SERVICE BULLETIN

Bulletin No: JC-13-23

Product Type: STEINER 440

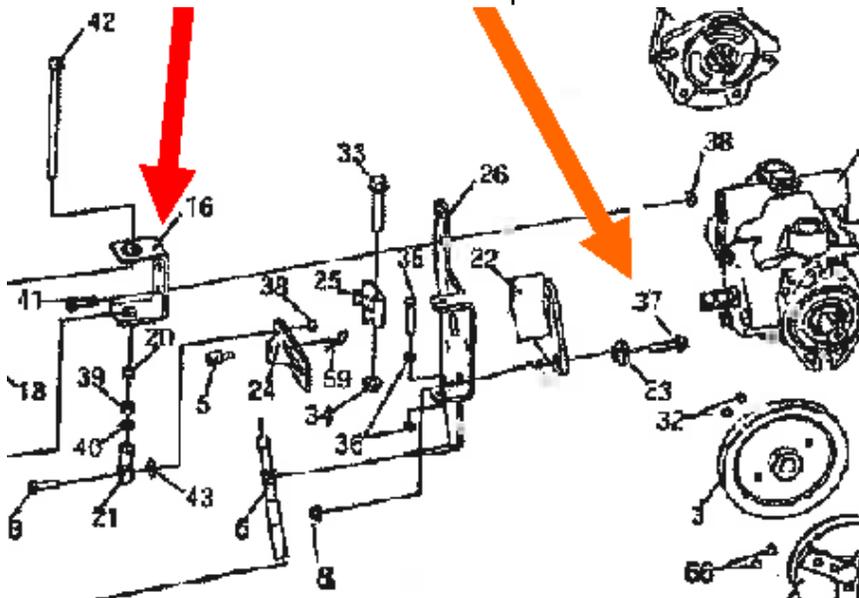
- A. Loss of Forward or Reverse drive speed.
- B. Parking brake hanging up not releasing the brake disc. This causes the disc to heat up and warp or wear the brake prematurely.

- A. F & R cable end could fail prematurely or the outside cable sheathing could break away from the crimp.
- B. There is not enough cable movement to allow the brake to release

- A. Remove the old F & R cable 128089-05 and 4168556-01.
 - 1. Order kit number 970485 and install all the new F & R linkage into the tractor including the new F & R cable 4169556. The directions are in the kit
 - 2. Neutralize the hydraulics and set proper F & R pedal movement to reach desired speeds.
 - 3. The neutral lock pivot bolt item 37 (orange arrow) must be installed as shown in the picture below.
 - 4. Some of the tractors will have a backup beeper switch bracket that was installed at the factory. When replacing item 16 (red arrow) neutralizing spring bracket, the backup beeper switch bracket (not shown) will be loose and can be removed if the tractor does not have the beeper kit installed.
